Agenda
Village of Arlington Heights
Design Commission
Community Room, 3rd Floor

Arlington Heights Village Hall
33 S. Arlington Heights Road
Arlington Heights, IL 60005
January 10, 2017
6:30 PM

MINUTES OF
THE VILLAGE OF ARLINGTON HEIGHTS
DESIGN COMMISSION MEETING
HELD AT THE ARLINGTON HEIGHTS MUNICIPAL BUILDING
33 S. ARLINGTON HEIGHTS RD.
DECEMBER 13, 2016

EAST ELEVATION

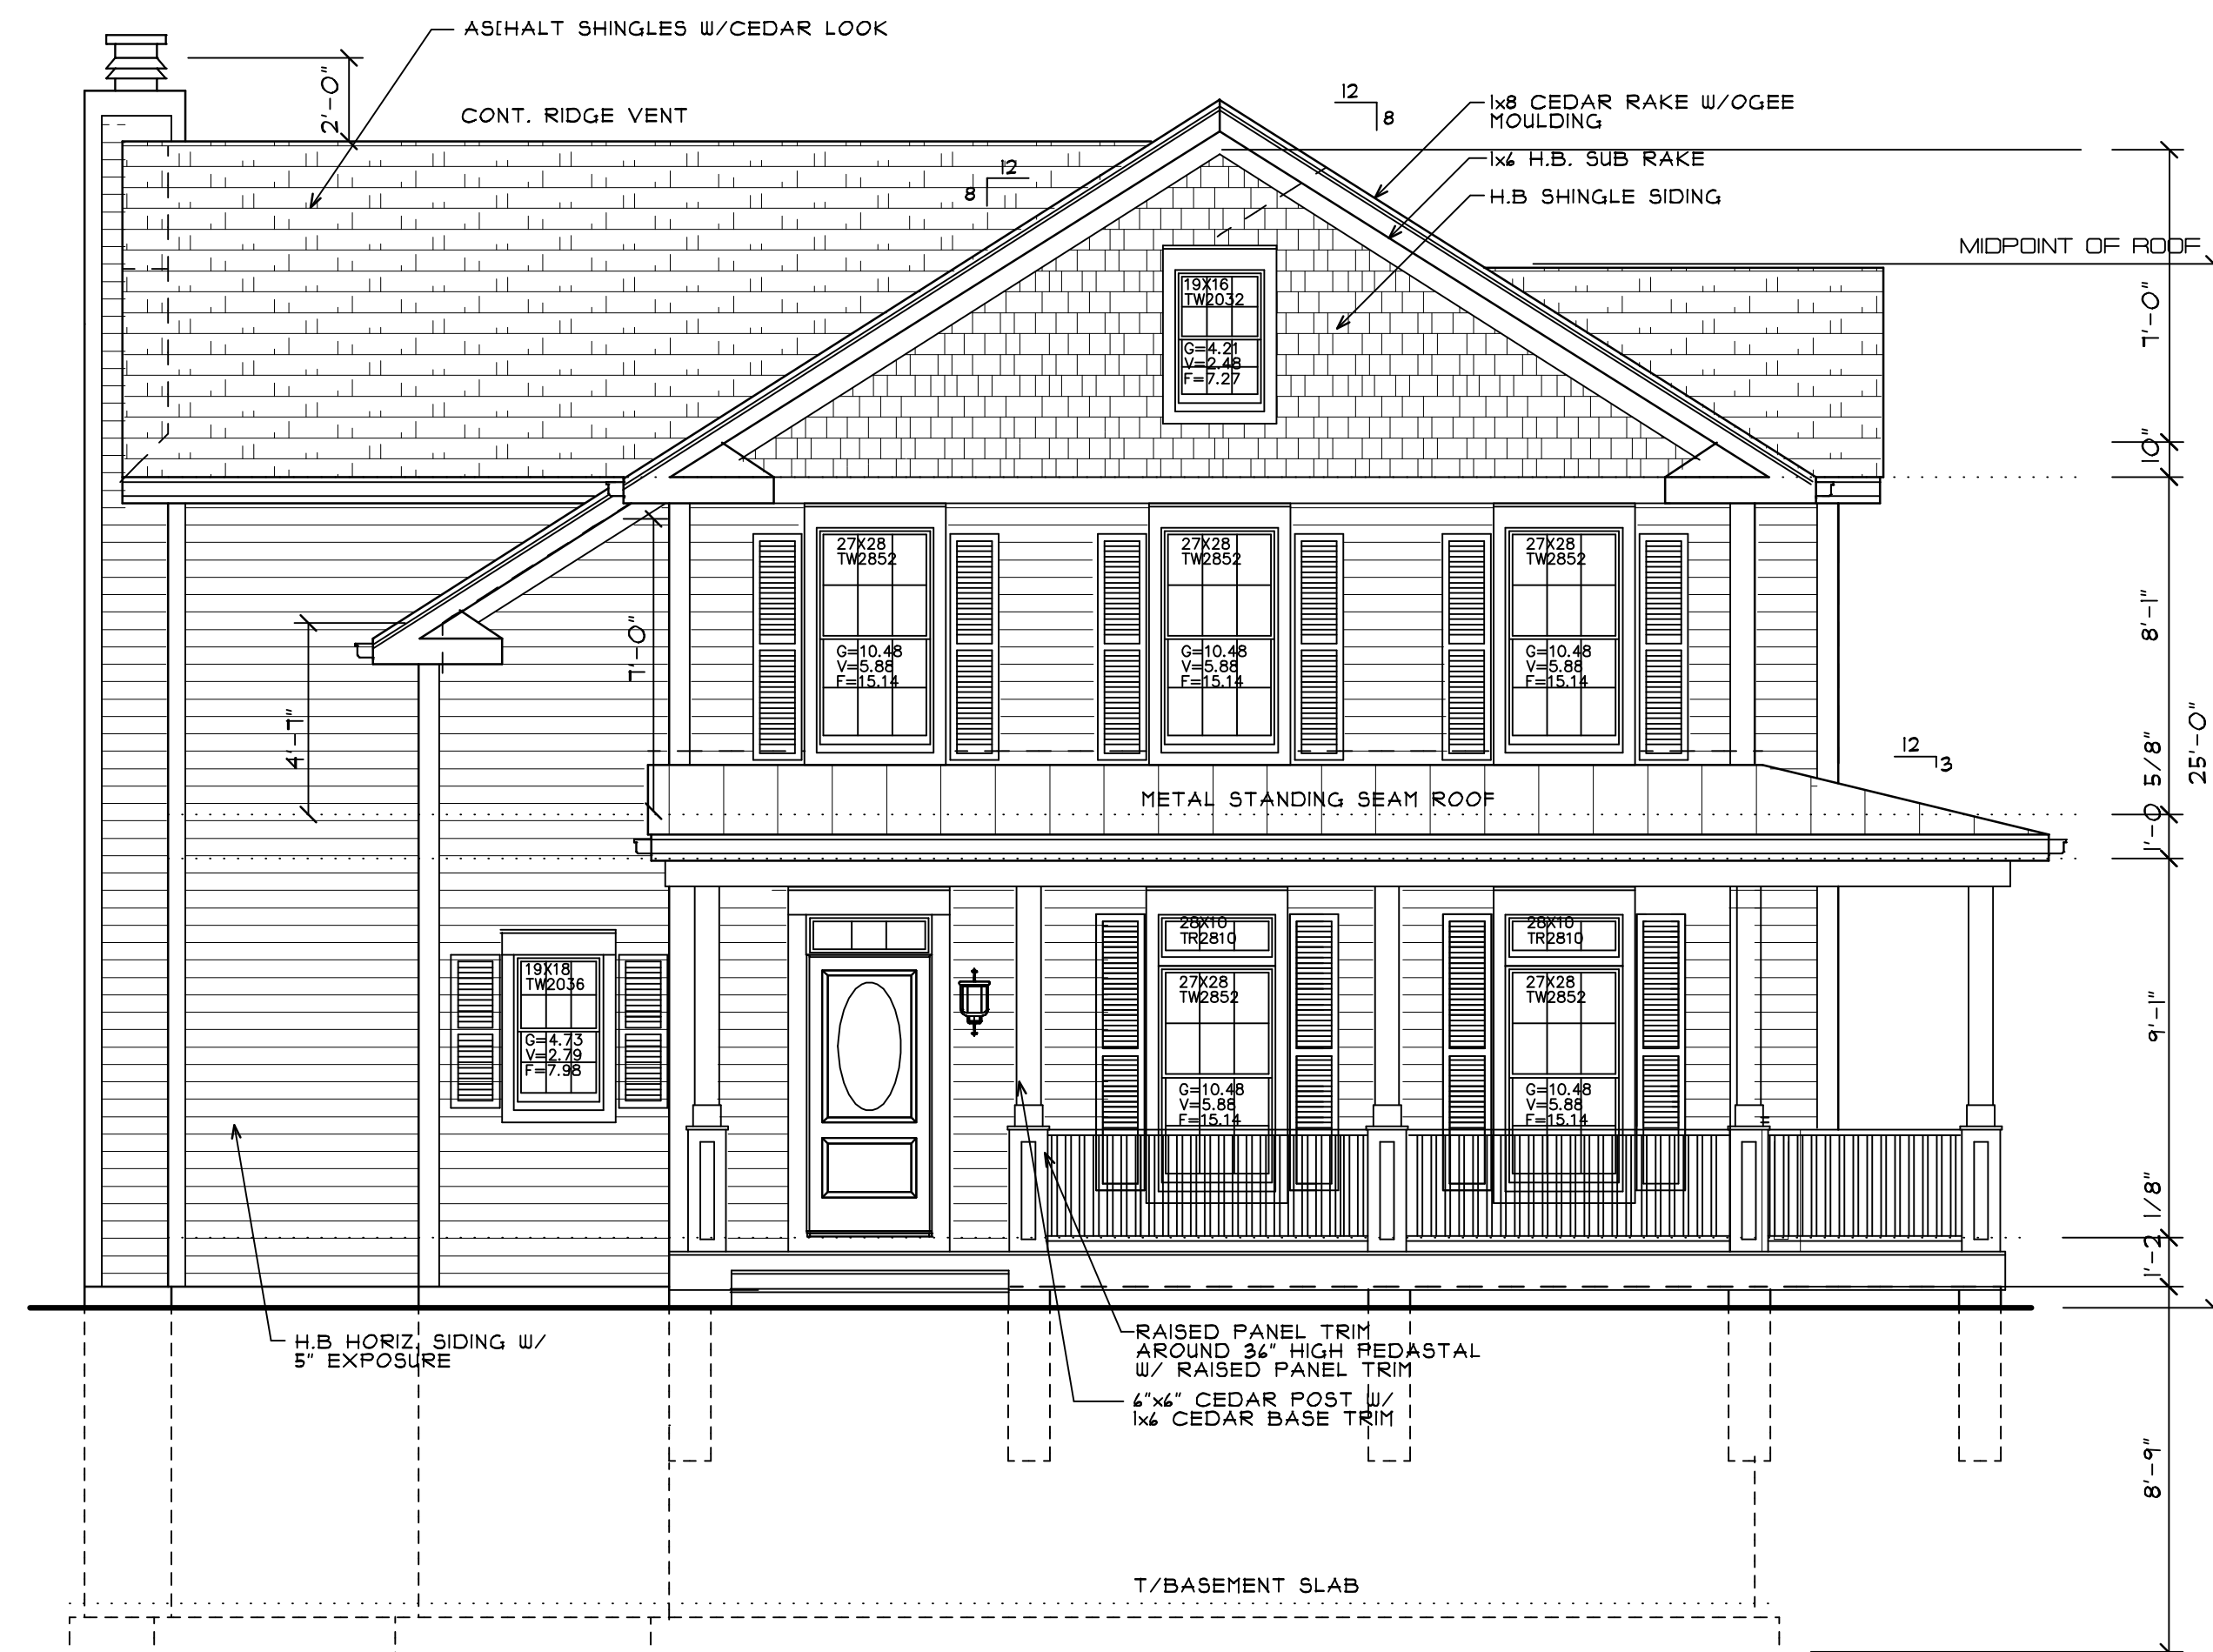
1. A recommendation to study the roof pitches, especially the left side of the west elevation.
2. A requirement to screen the air conditioning unit with either fencing or evergreen landscaping.
3. A requirement for window detail and shutters throughout the entire home to match the front elevation.
4. A recommendation to provide a landscape plan.
5. A requirement that the petitioner work with Staff to look at options for lowering the roof scale.

In response to these comments, the petitioner has made the following changes to the design:

1. The second floor wall height has been lowered, and shed dormers added above the windows.
2. The main roof pitch has been increased from 8:12 to 10:12, and the north side gable pitch increased from 7:12 to 10:12.
3. The front porch has been wrapped around the left side of the house.
4. Window trim and shutters have been added to all windows to match the front elevation.
5. A landscape plan has been provided with an evergreen hedge to screen the air conditioning unit.

WINDSOR ELEMENTARY SCHOOL ADDITION AND RENOVATIONS

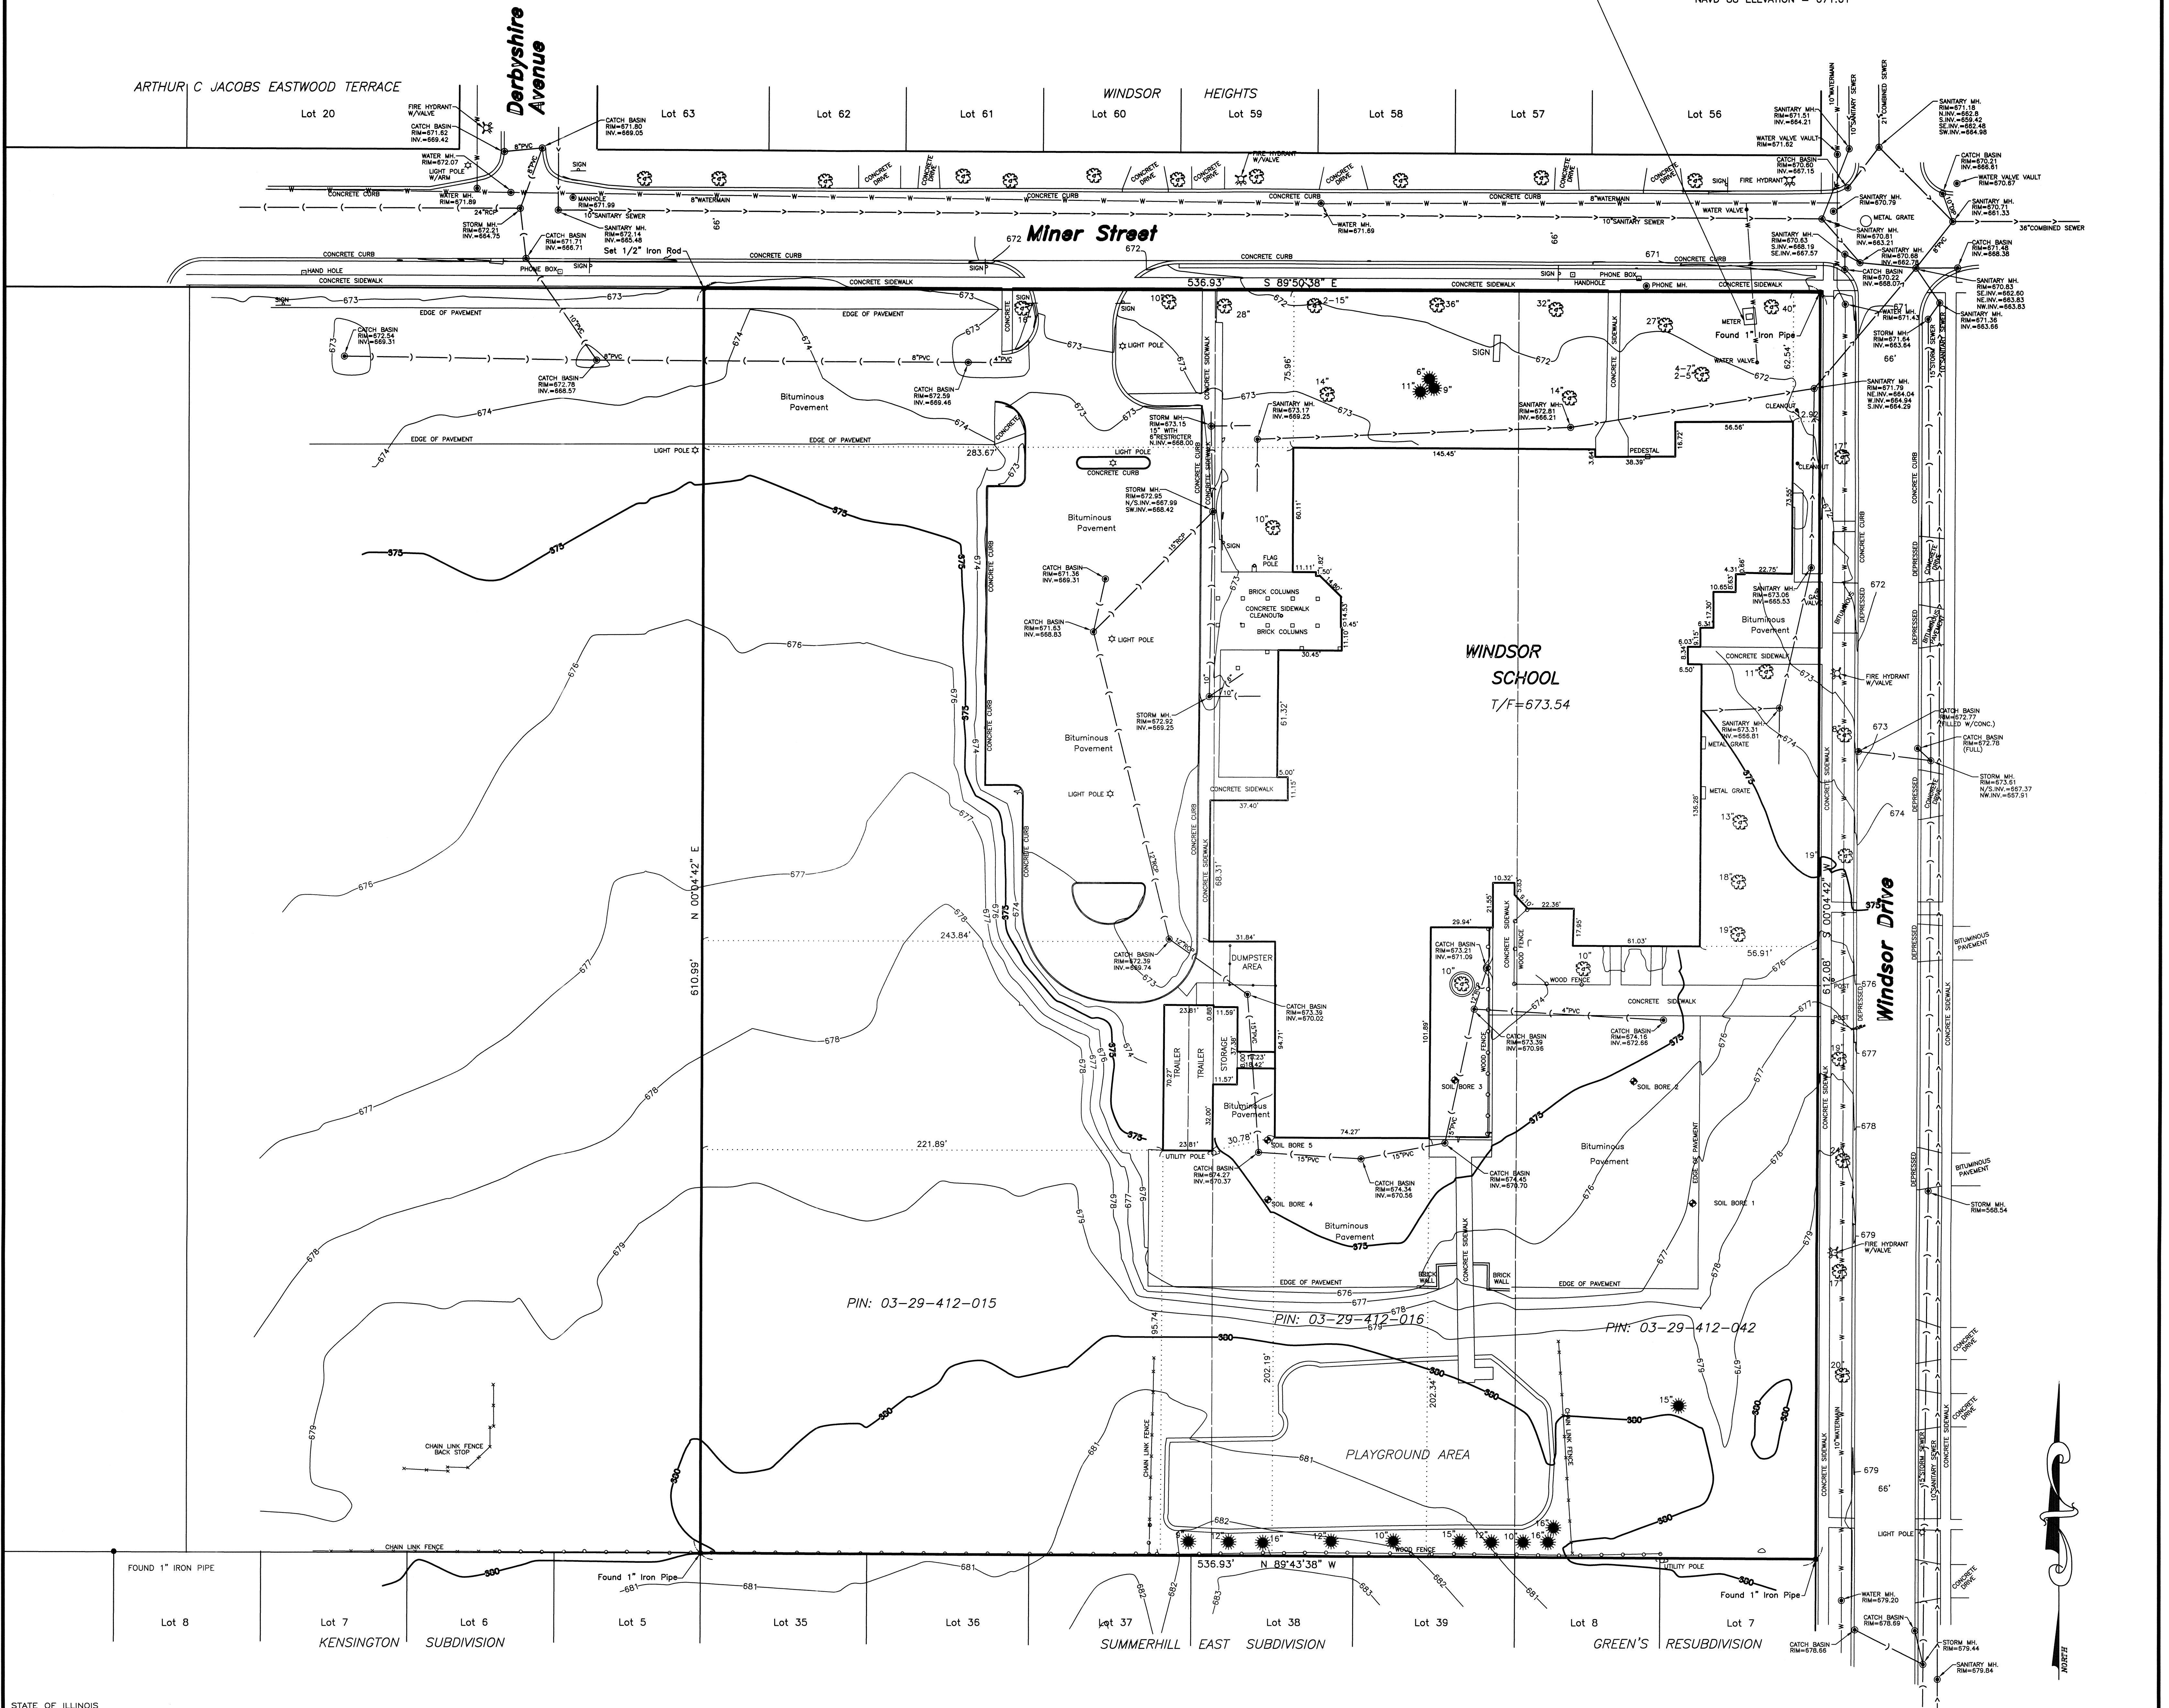
The existing school building lacks foundation landscaping around the exterior walls of the school along Miner Street and Windsor Drive. The petitioner should consider adding planting beds in these locations with a mix of shrubs and perennials.

1. Consider adding planting beds with a mix of shrubs and perennials along the existing building walls facing Miner Street and Windsor Drive.
2. This review deals with architectural design only and should not be construed to be an approval of, or to have any other impact on nor represent any tacit approval or support for the proposed land use or any other zoning and/or land use issues or decisions that stem from zoning, building, signage or any other reviews. In addition to the normal technical review, permit drawings will be reviewed for consistency with the Design Commission and any other Commission or Board approval conditions. It is the architect/homeowner/builder's responsibility to comply with the Design Commission approval and ensure that building permit plans comply with all zoning code, building permit and signage requirements. The petitioner is required to comply with Village standards for sidewalks, street trees, and site furnishings.
